MEETING:	PLANNING AND REGULATORY COMMITTEE
DATE:	27 SEPTEMBER 2018
TITLE OF REPORT:	<p>182314 - SUMMARY DESCRIPTION (FOR FULL DESCRIPTION SEE APPLICATION FORM AND PLANNING CASE STATEMENT): • PROPOSED NEW FIELD ACCESSES • PROPOSED MAINTENANCE TRACKS TO SERVE SOUTHERN LINK ROAD (APPLICATION 151314) AT MULTIPLE PARCELS OF AGRICULTURAL LAND, SOUTHERN LINK ROAD CORRIDOR (151314) A465 - A49, HEREFORDSHIRE</p> <p>For: Mrs Lane per Mr Jiggins, WSP, The Victoria, 150-182 The Quays, Salford, Manchester, M50 3SP</p>
WEBSITE LINK:	https://www.herefordshire.gov.uk/info/200142/planning_services/planning_application_search/details?id=182314&search=182314
Reason Application submitted to Committee – Council owned land with objections

- 1.2 The applicants, Herefordshire Council, are seeking planning permission for ancillary works that lie outside the original application boundary. These proposals relate primarily to minor alterations; including the creation of new accesses (and field gates), alterations to property boundary (Pykeways) and alterations to drainage arrangements. The most notable piece of development required is the construction of a temporary haulage route. These proposals are describ

Sheet 10 – new field access in fenceline at Dunan Lodge (onto driveway)

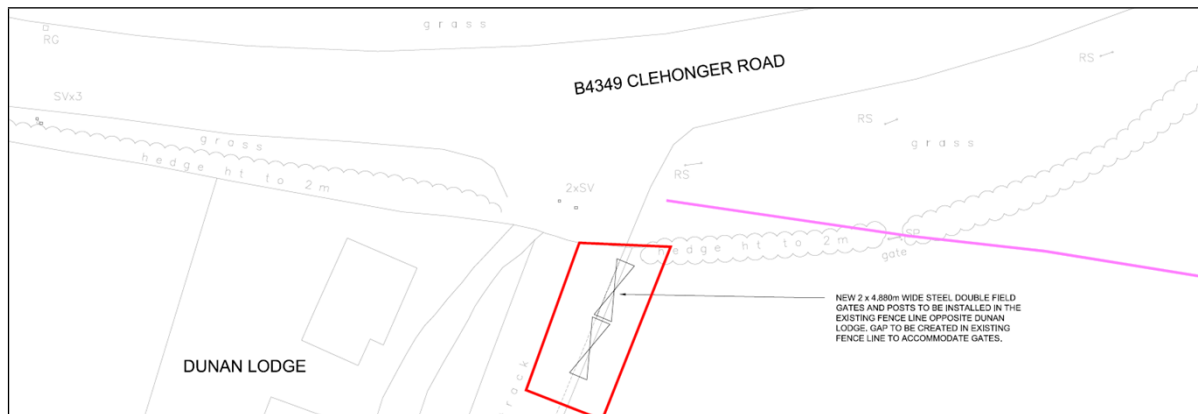
- Sheet 10 – New gates will encourage additional traffic on a bend with poor visibility and history of accidents (McIntryes bend). Idea of farm traffic using this is frightening.

Drawing no. 3512983BP- WSP-ZO- XX-DR-T- 00010-P04 Sheet 10	Off the B4349	This is now acceptable, please see conditions as follows. CAS, CAZ	No issues subject to conditions.
